Technical Newsletter

FLATSCREEN PICTURE IMPROVEMENT

Subject: Hazy letters on your flatscreen display of the dispenser.

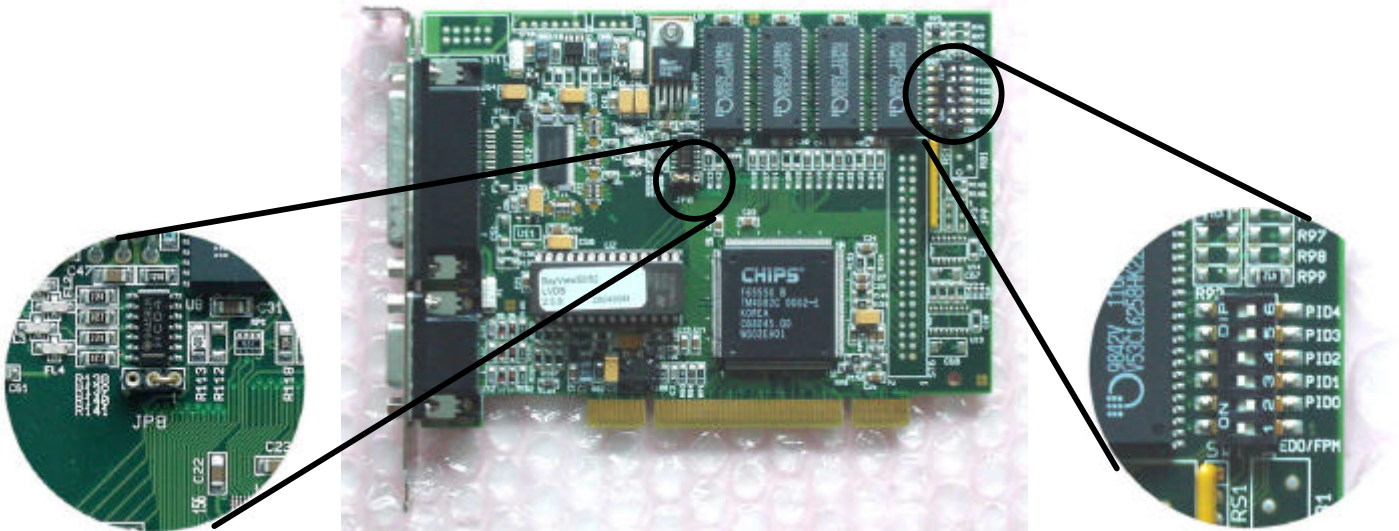
Solution: Change JP8 like in the picture below.

See also the settings of the Dip-Switch in the picture.
The setting must not be changed and should be like in the picture.

How: Switch off the computer and take the cover off.
Take the card out of the computer and look at the JP8
If it is not in the position like in the picture then change it over.
If the jumper is in the position like in the picture then it is set optimal.
